Economic Commission for Europe**Inland Transport Committee****World Forum for Harmonization of Vehicle Regulations****Working Party on Noise****Fifty-seventh session**

Regulation No. 51 (Noise of M and N categories of vehicles) – Development**Proposal for Supplement 9 to the 02 series of amendments to Regulation No. 51****Submitted by the expert from China¹**

The text reproduced below was prepared by the expert from China to introduce amendments to the test method. The proposal is based on a document without symbol (GRB-56-06) distributed at the fifty-sixth session of the Working Party on Noise (GRB)(ECE/TRANS/WP.29/GRB/54, para. 9). The modification to the existing text of the UN Regulation, are marked in bold for new or strikethrough for deleted characters.

Figure 1

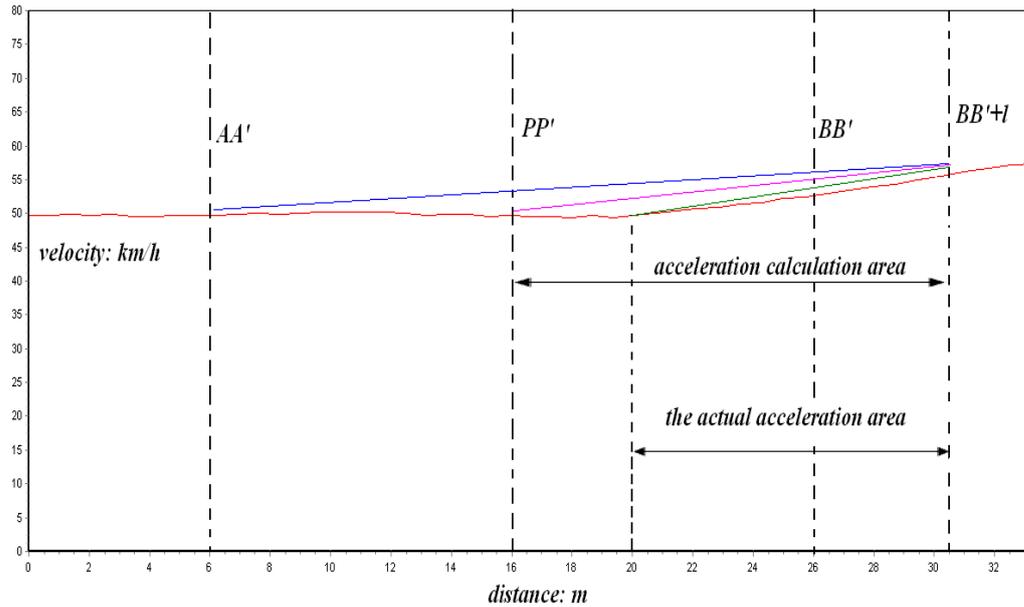
The influence of acceleration delay

1. Conclusion: If the pre-acceleration is not used, vehicles with non-locked gear transmissions cannot test their real acceleration, when the acceleration time delay is longer than 0.7 seconds. Accordingly, pre-acceleration of 4 metres is needed to ensure that a real acceleration can be reached. Moreover, the test accelerations $a_{\text{wot test}} = a_{\text{wot ref}}$ is related to the $k_P = 1 - (a_{\text{urban}} / a_{\text{wot ref}})$ weighting factor, and will influence the final result. Therefore, the expert from China is of the opinion that is relevant to obtain an exact and equitable acceleration when the test for automatic transmission vehicles is performed.

Figure 2
Situation of exceed S and the deceleration delay of commercial vehicles

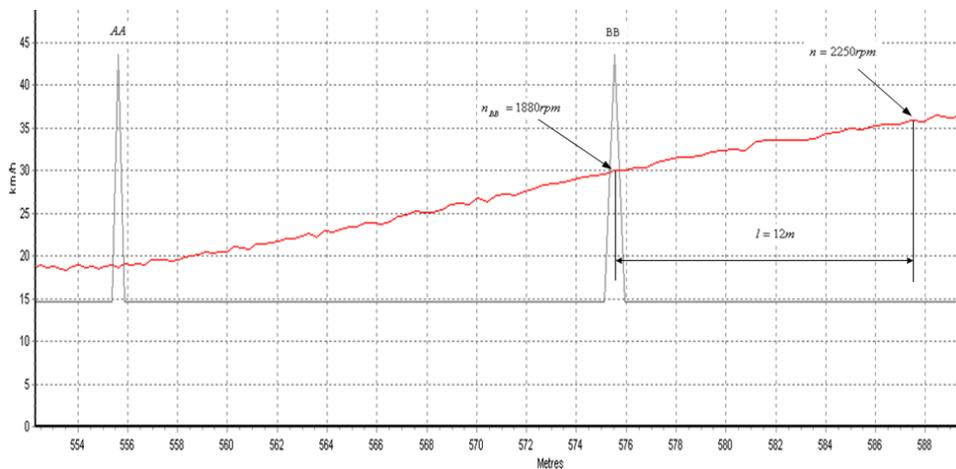
- (a) Some vehicles, particularly those equipped with front engines, even the nBB' can fulfil the target condition. However, when the rear of the vehicle passes the BB line the engine speed could exceed the rated engine speed (S), so that a test report containing only the nBB' and nAA' is insufficient.
- (b) The condition of engine speed exceeds S in not a recommended working condition by manufacturers. Accordingly, such working condition should not be covered by the test procedure.
- (c) There is always a deceleration delay when the acceleration pedal is released, so that the maximum engine speed does not correspond at the moment when is released the acceleration pedal.
